ATR on Quality Control Check Report. (Apartments)

Quality Control Check Repot. Stage: After Finishing Stage III (Apartments)

MEASUREMENT SHEET											
Company Name:		MPL									
Project:		May Flower Platinum									
Work Description:		Extra Specs									
Flat No.		A-1006									
Prepared By		K. Narender Reddy									
Date:		14-10-2021									
S No.	Item Head	Item Description			Length	Width	Height	Nos.	Quantity	Units	Item Head Total
1	Big Tiles	Big tiles laying at Drawing and Dining area			635.00	1.00	1.00	1.00	635.00	sft	635.00
2	UPVC Window	Mesh Provision for windows			5.00	1.00	4.00	1.00	20.00	sft	
					6.00	1.00	4.00	1.00	24.00	sft	
					4.00	1.00	3.00	2.00	24.00	sft	68.00

Details of Additions & Alterations

Description	Direction	Owners & Developers :	Date :	18.03.2020	Promoted by
WORKING DRAWING OF FLAT.NO.A-6		Modi Properties Pvt Ltd.	Prepared By :		Modi Properties Pvt. Ltd Phone:+91-40-66335551
		Project Name & Phase :	Approved By :	Soham Modi	
		MAYFLOWR PLATINUM	Scale :	N.T.S

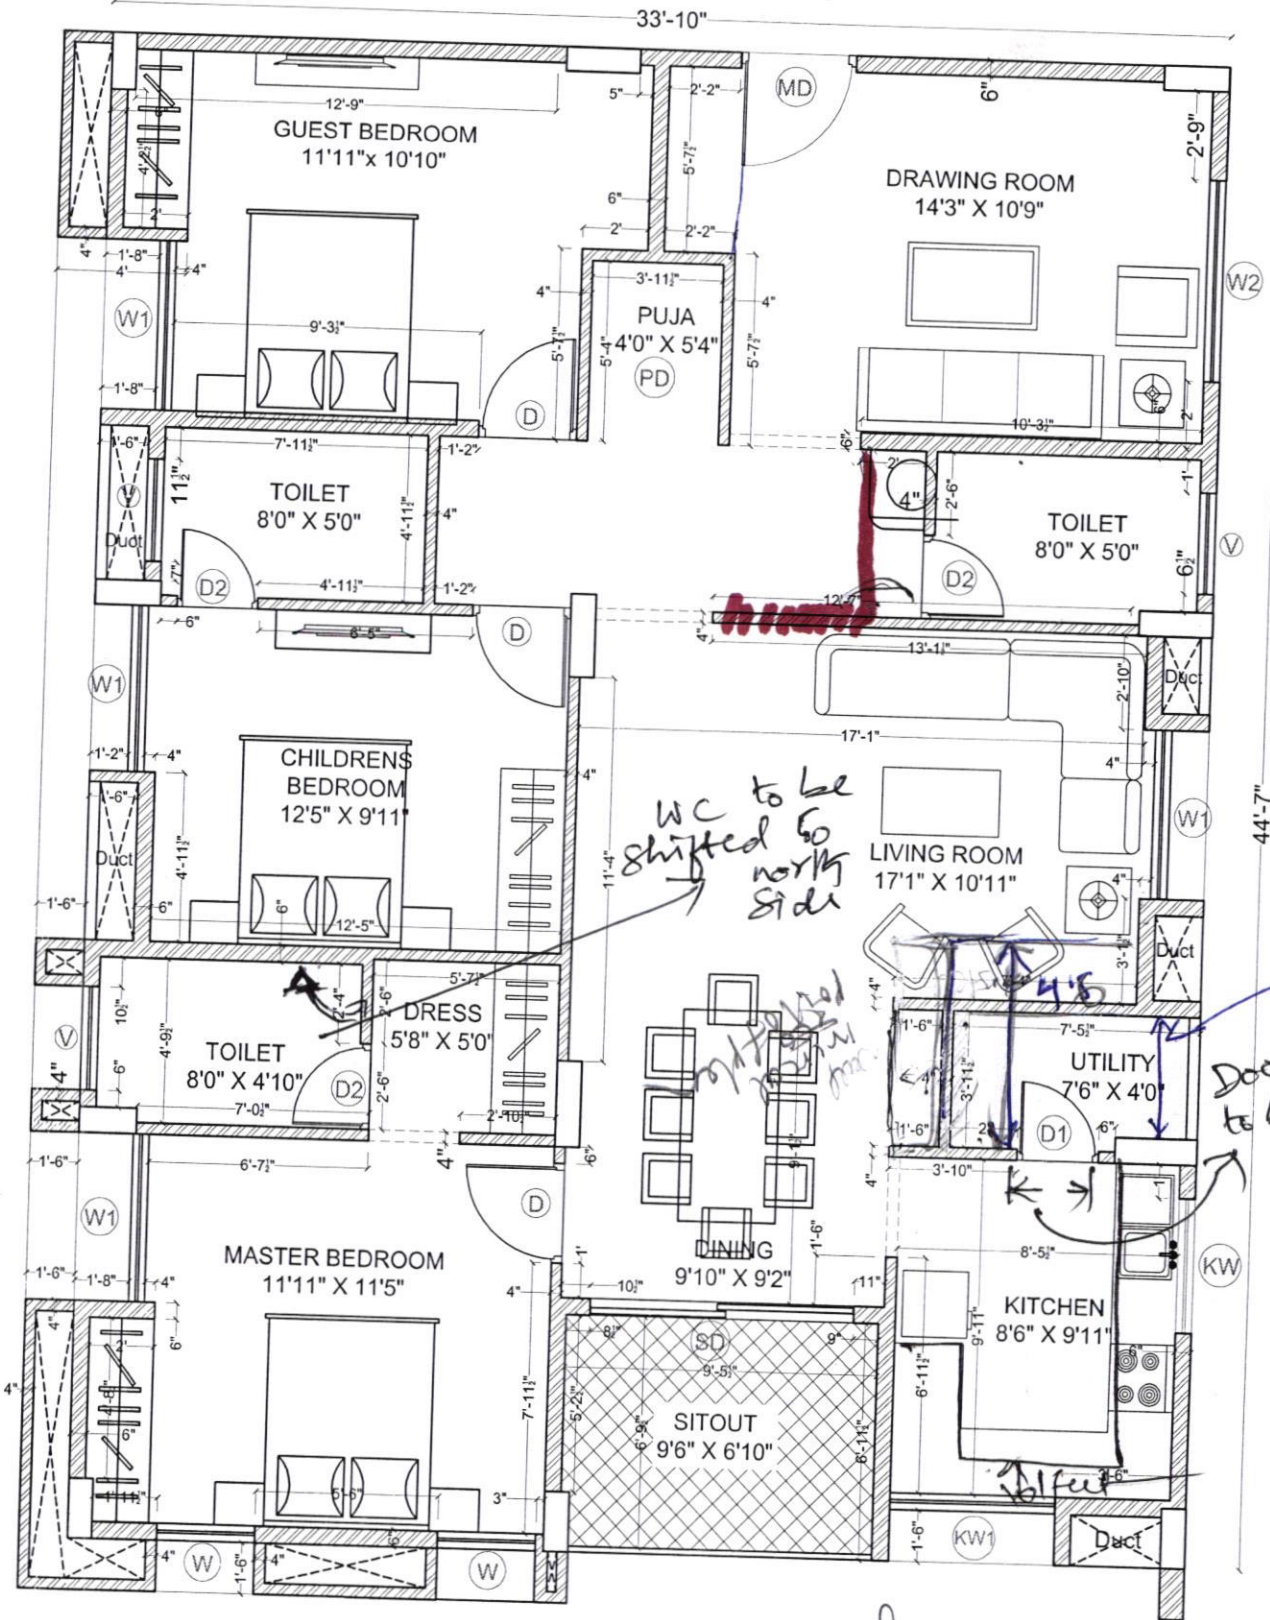
- 1) *Main door should be shifted to the north east corner.
- 2) Children bed room and guest bed room doors should be exactly opposite.
- 3) Balcony mirror thickness to be 6mm in size.
- 4) Utility wall to be extended ~~and~~ to wash basin wall marked in plan
(Door. ~~2.5~~ feet is required)
3.0 feet
- 5) All windows 3 track with mesh (21/12/20) *

Description		Direction		Owners & Developers :		Date :	Promoted by	
ELECTRICAL PLAN OF FLAT-A6				BNC Estates		Prepared By :	02.12.2019	
				Project Name & Phase :		Approved By :	Soham Modi	
				Mayflower Grande		Sd/	N.T.S	
							Modi Properties & Investments Pvt. Ltd. Phone: +91-40-66335551

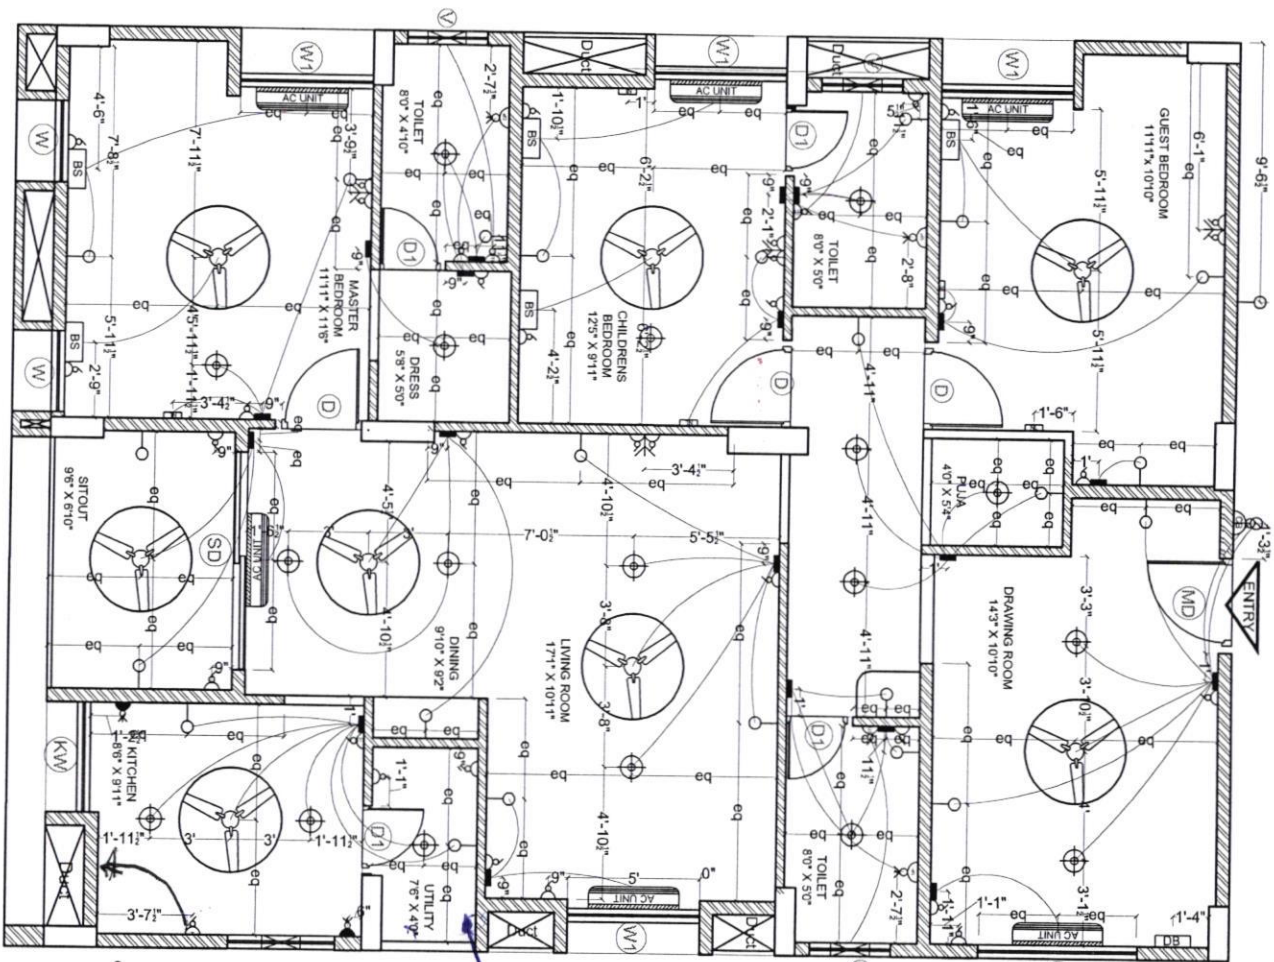
- 1) Kitchen Platform above stove point
plug point should be shifted towards
South wall.
- 2) Platform 'U' shape After Confirmation
by me. (Budget estimation is required)
- 3) Inventory points 3 - bedrooms - one socket each.

↓
To be shifted electrical point -
(15 Amp) South side wall
16 mtr for distance
Soham Modi
Investments Pvt. Ltd.
Phone: +91-40-66335551
